PIC16F88X Family Silicon Errata and Data Sheet Clarification

The PIC16F88X family devices that you have received conform functionally to the current Device Data Sheet (DS41291G), except for the anomalies described in this document.

Data Sheet clarifications and corrections start on page 14, following the discussion of silicon issues.

FIGURE 1: SCK PULSE VARIATION USING TIMER2/2

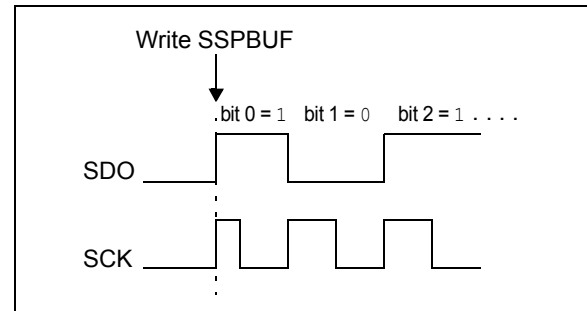
When the SPI is using Timer2/2 as the clock source, a shorter than expected SCK pulse may occur on the first bit of the transmitted/received data ([Figure 1](#)).

To avoid producing the short pulse, turn off Timer2 and clear the TMR2 register, load SSPBUF with the data to transmit and then turn Timer2 back on. Refer to [Example 1](#) for sample code.

FIGURE 1: ACTUAL (CORRECT) OPERATION WITHOUT CLOCK STRETCHING

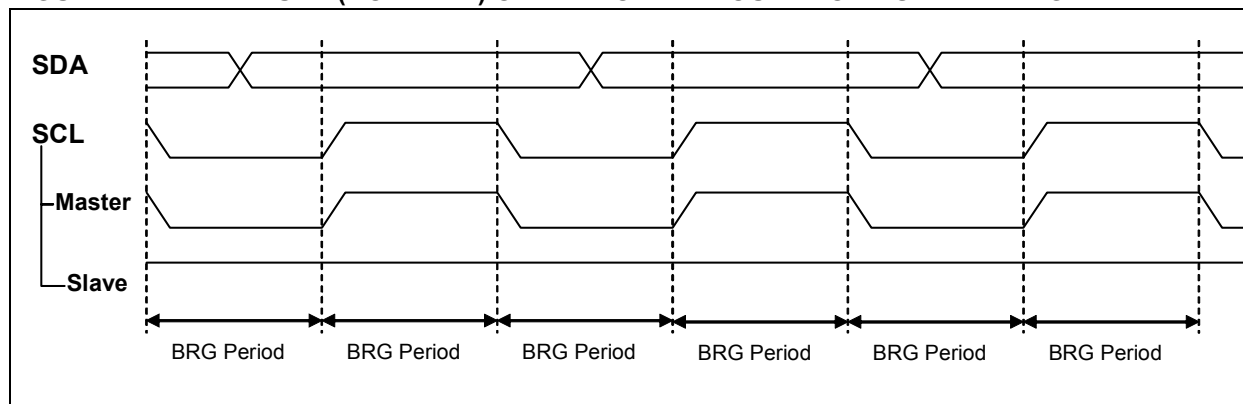
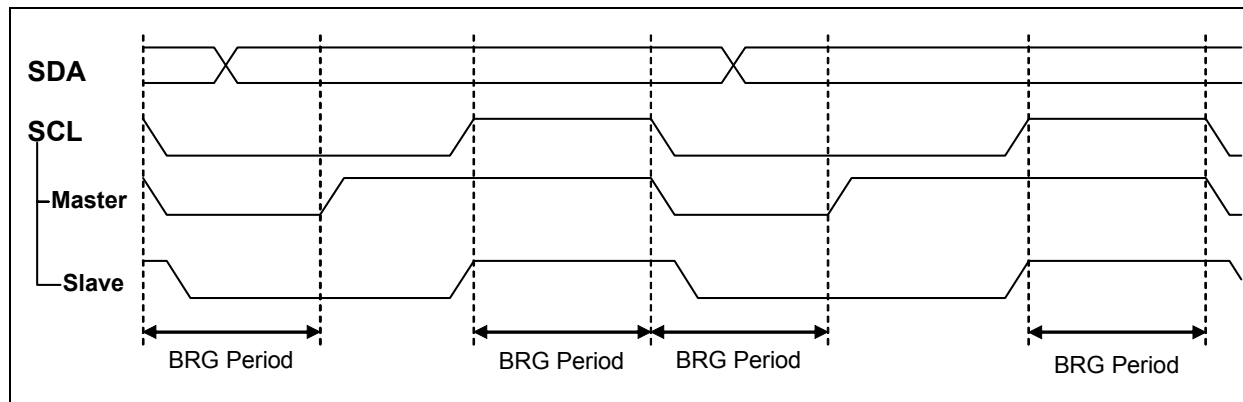
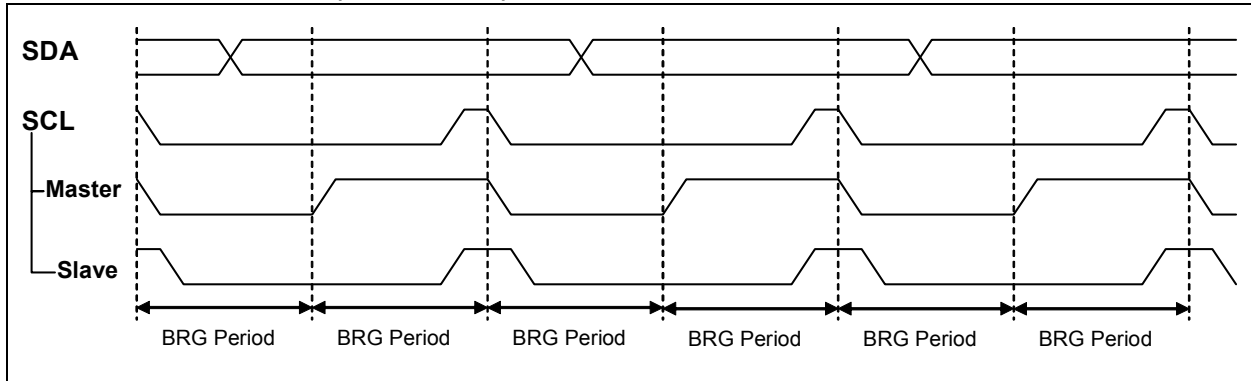
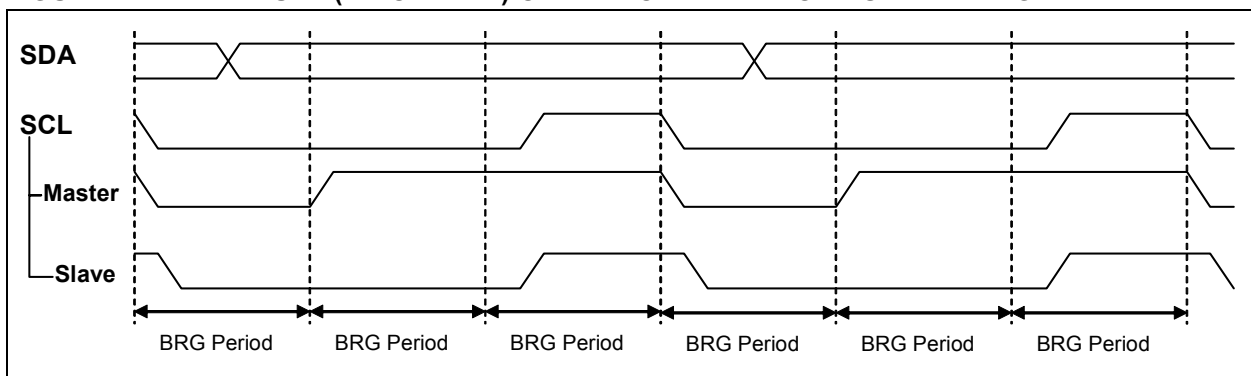
When the MSSP is I²C™ Master mode with a slave device stretching the clock, the clock generation does not function as described in the data sheet.

When a slave device is performing clock stretching by pulling the SCL line low, the master device should continuously sample the SCL line to determine when all slaves have released SCL. When SCL is released, the master device should wait one BRG period to ensure a constant SCL high time.

The current implementation does not ensure accurate SCL high time. During clock stretch, the MSSP device will erroneously continue running the BRG counter. At the end of the clock stretch, the BRG counter continues to count down for the

remainder of the BRG period, and then the MSSP device will immediately resume transmitting the data.

Figure 1 illustrates an expected I²C transmission in which the SCL line is completely controlled by the master device and the slave device does not attempt to stretch the clock period.

Figure 2 illustrates the expected operation of an I²C transmission in which the slave device has stretched the clock period by holding the SCL line low. The high time of the SCL pulse is constant, regardless of the duration of the clock stretch.

Figure 3 and Figure 4 illustrate an actual I²C transmission in which the slave has stretched the clock period by holding the SCL line low. Note that the high time of the SCL signal has shortened from the expected time.

Set the communication speed to match the slowest device on the bus. This ensures that no slave device will perform clock stretching.

It is possible to dynamically adjust the communication speed to match the device being addressed by modifying the BRG register. However, the behavior of slower slave devices must be understood and speed adjustments made such that no slave performs clock stretching.
